# Access Compliance Report

## Public Rights-of-Way

Intersection ID: 31934	Main Street: STEELE_CREEK_RD	Cross Street: BRANCH_BEND_LN	Location: W
ADA ID: D07C3D75CF AF	Ramp Type: BlendTrans2	Initial Pass/Fail: Fail	Overall Compliance: No
		Severity Score: 12.5

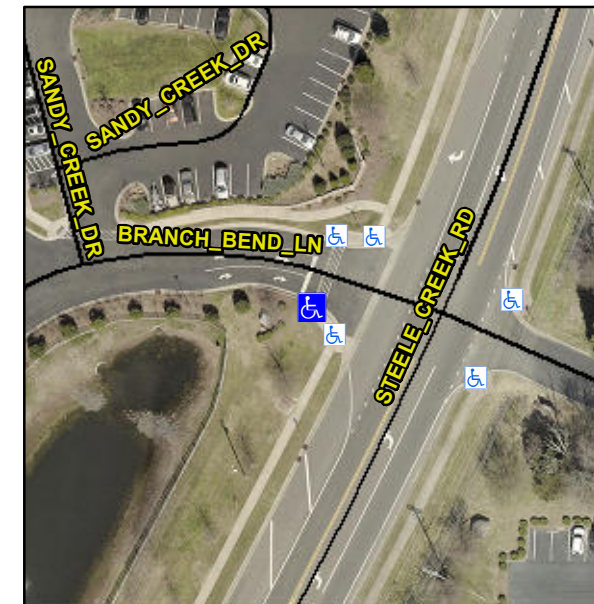
Compliance	Description	Data	Compliance	Description	Data
N/A	Ramp Length (in)	85.0	Yes	BlendTrans Slope (%)	0.8
Yes	Ramp Width (in)	60.0	No	BlendTrans XSlope (%)	6.2
N/A	Flare Type LT	N/A	N/A	Flare Type RT	N/A
N/A	Flare Slope LT (%)	N/A	N/A	Flare Slope RT (%)	N/A
N/A	Flare Traversable LT?	N/A	N/A	Flare Traversable RT?	N/A
N/A	Landing Length (in)	N/A	N/A	DWS Provided?	N/A
N/A	Landing Width (in)	N/A	N/A	DWS Contrast?	N/A
N/A	Landing Slope (%)	N/A	N/A	DWS Length (in)	N/A
N/A	Landing X Slope (%)	N/A	N/A	DWS Full Width?	N/A
N/A	Landing Curb? (Y/N)	N/A	N/A	DWS Offset (in)	N/A
N/A	Shared Landing?	N/A			
N/A	Gutter Ponding?	N/A	N/A	Gutter Slope (%)	N/A
N/A	Gutter Lip Ht (in)	N/A	N/A	Gutter X Slope (%)	N/A
N/A	Painted X Walk1?	Yes	N/A	Painted X Walk2?	N/A
	X Walk 1 Direction	To N		X Walk 2 Direction	N/A
	X Walk 1 Width (in)	61.0		X Walk 2 Width (in)	N/A
	X Walk 1 Slope (%)	2.3		X Walk 2 Slope (%)	N/A
	X Walk 1 X Slope (%)	2.7		X Walk 2 X Slope (%)	N/A

**Remove & Replace Curb Ramp With Two New Directional Ramps or Equivalent.**

**R304.5.3**
